From: Jones, William V., EMNRD
Sent: Thursday, November 17, 2011 5:12 PM
To: 'John.Alexander@duganproduction.com'
Cc: Ezeanyim, Richard, EMNRD; 'Wesley_Ingram@blm.gov'; Gonzales, Elidio L, EMNRD
Subject: Disposal application from Dugan Production Corp.: Bilbrey 51 #1 30-025-24321 San Andres

APPLICATION FOR AUTHORIZATION TO INJECT

Application for Authorization to Inject
Bilbrey 51 No.1

Application for Authorization to Inject

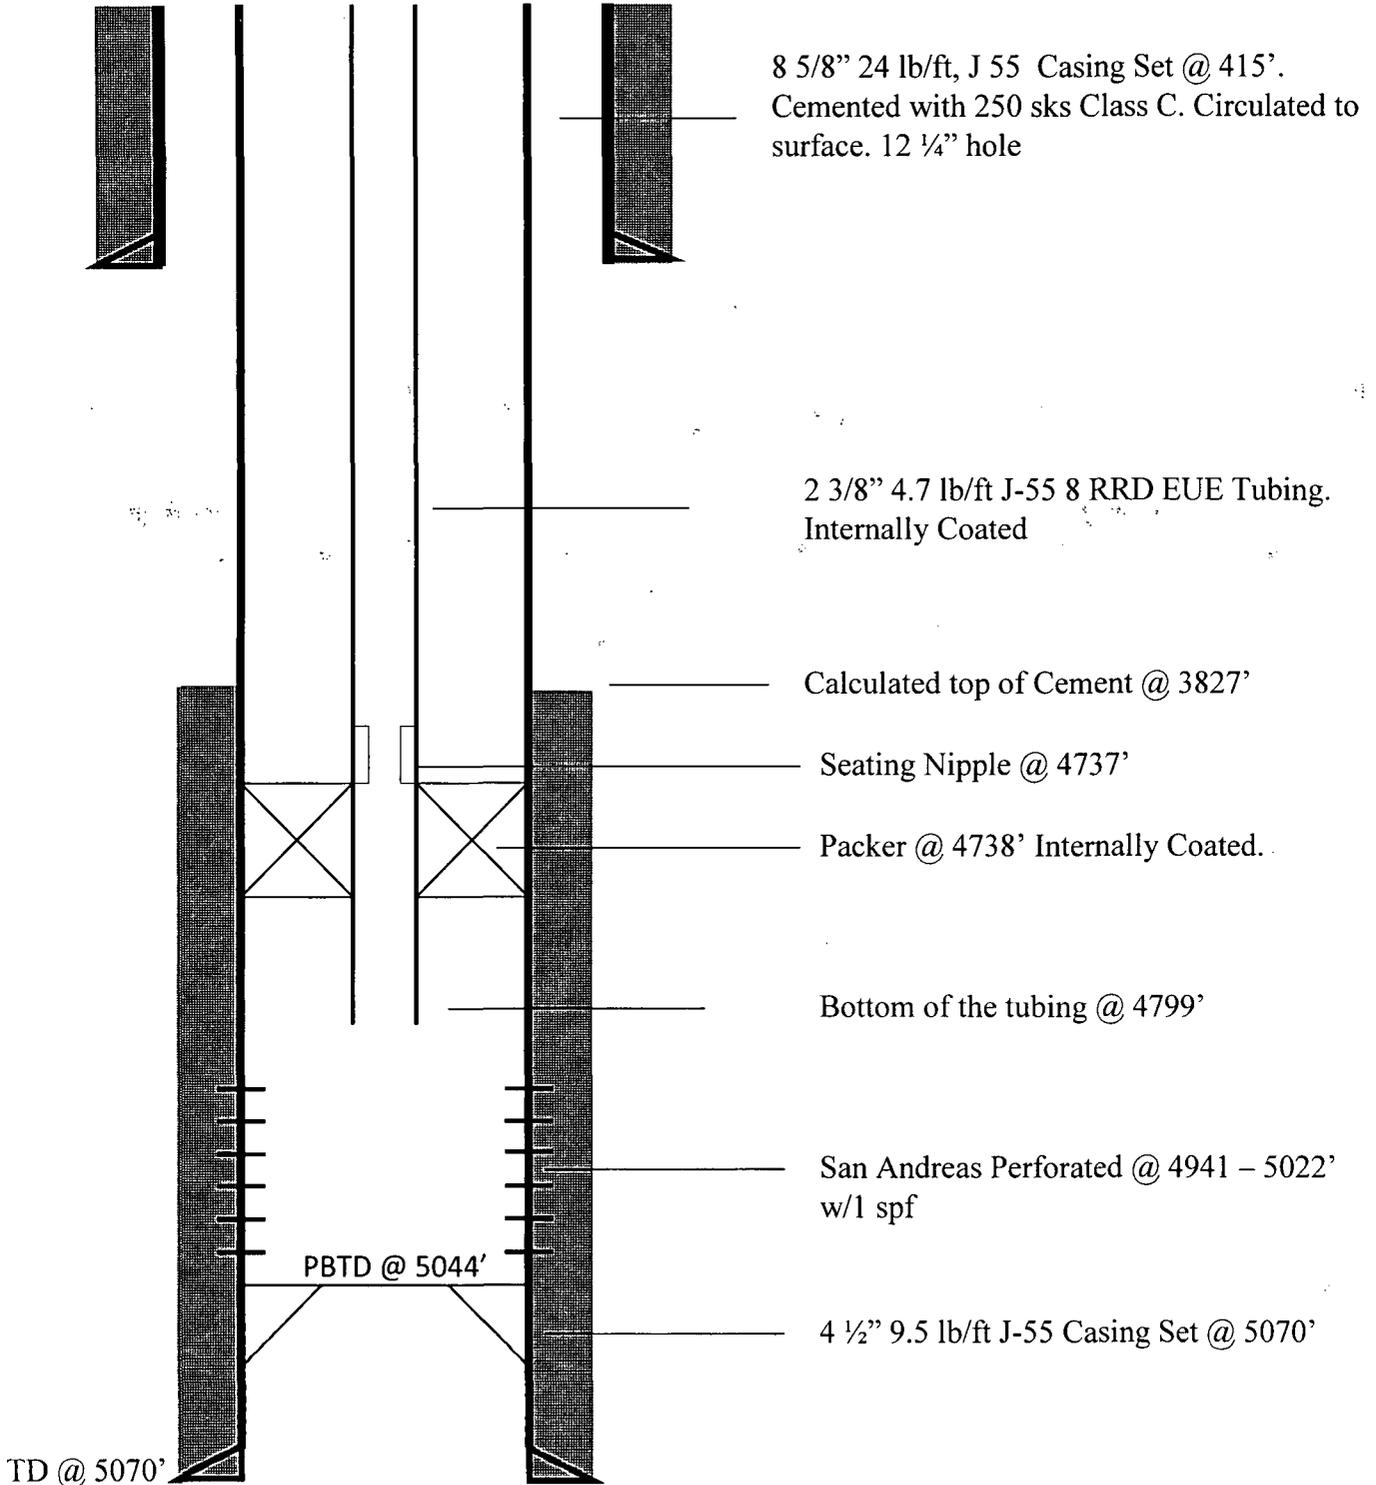
The wellbore diagram does not show any stranded packers – but the proposed packer setting depth is about 200 feet above the interval. We normally require 100 feet maximum, but you could ask for a higher packer setting depth in the hearing with reasons why it could not be set closer.
